WATTS BAR NUCLEAR PLANT UNITS 1 AND 2 - SOLID-STATE PROTECTION SYSTEM TEST PROCEDURES - WBRD-50-390/82-91, WBRD-50-391/82-87 - FINAL REPORT

WATTS BAR NUCLEAR PLANT UNITS 1 AND 2
SOLID-STATE PROTECTION SYSTEM TEST PROCEDURES
NCR WBN NEB 8217
WBRD-50-390/82-91, WBRD-50-391/82-87
10 CFR 50.55(e)
FINAL REPORT

ATTACHMENT
SIMPLIFIED SKETCH OF SSPS TEST CIRCUIT
(SAFEGUARDS ACTUATION RELAY)

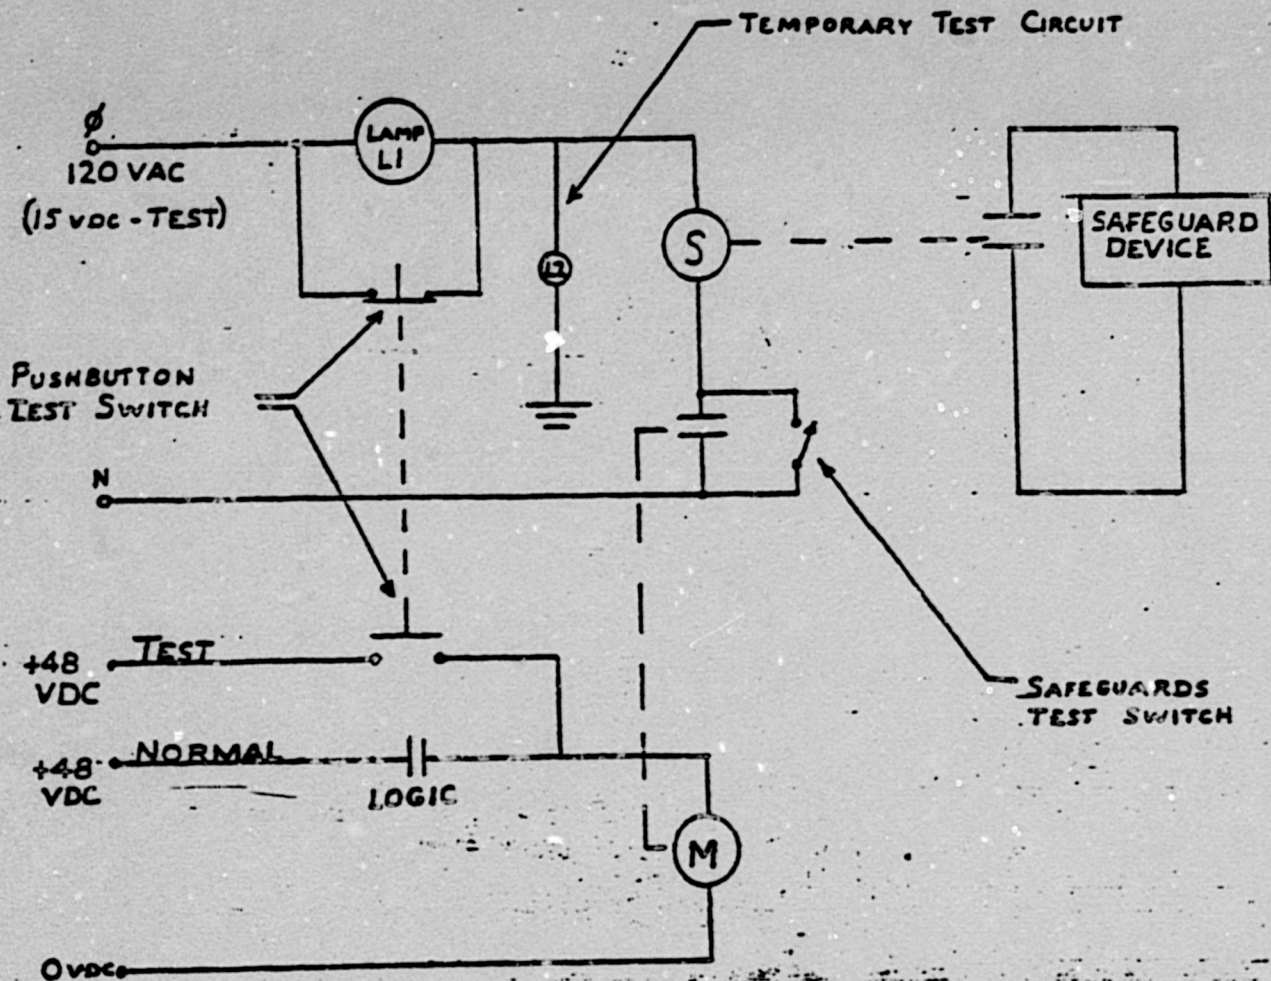
During periodic testing of the Solid State Protection System (SSPS), the master relays which actuate safeguards systems are energized. The master relays, in turn, actuate the slave relays under operating conditions. However, during testing the voltage to the slave relays is reduced from 120V ac to 15V dc which allows checking electrical continuity through the slave relay coil without energizing the relay and actually starting the safeguards equipment. There is a test light in series with the slave relay which normally has a shunt around it. During testing the shunt is removed such that when the master relay contacts close, if the slave relay circuit is continuous, the test lamp will light. If, after testing, the switch which opens the shunt does not reclose, then a subsequent accident signal would apply 120V ac to the lamp which would cause it to burn open. This would prevent actuation of the slave relay. With present test procedures, this failure is undetectable. Both the SSPS and the test procedures were provided by Westinghouse Corporation, Pittsburgh, PA, who has determined that this deficiency was caused by a design error committed in a 1974 revision to the SSPS design.

This undetected switch failure could result in a subsequent slave relay circuit failure. Since the slave relays are required to actuate safeguards equipment, their failure could result in a partial or complete failure of a system to achieve its safety function.

TVA has implemented a procedural change (S. I. 3.1.26, revision 3) which initiates use of a test probe with an indicator lamp connected to ground and to a point between the shunt switch and the slave relay. (See attachment)

After returning the shunt switch to its normally closed position, this additional test circuit would give one of three indications:

1. Both the probe lamp and the relay test lamp would light which would indicate failure of the shunt switch.
2. Neither lamp would light which would indicate failure of both the shunt switch and the relay test lamp.
3. The probe lamp would light while the relay test lamp would remain dark. This would indicate proper restoration of the shunt.

If the shunt has been restored, then the probe circuit would be removed and the operating voltage of 120V ac would be restored to the slave relay circuit.

Normal Operation: "Logic contacts close to pick up Master relay M.
 Master relay contacts close to apply 120V ac to Slave relay S.
 Slave relay contacts close to power the Safeguards device.

During Testing: Relay mode selector switch (not shown) to "Test" position switches 120V ac to 15V dc.
 Pushbutton test switch picks up Master relay M and applies 15V dc to Slave relay coil thru proving lamp L.
 Slave relay is not energized because of reduced voltage of 15V dc.
 Test Circuit 2 indicates correct return of pushbutton.
 Test Switch by Lit-Unlit status of L2. Circuit is removed before returning slave circuit to 120V ac.
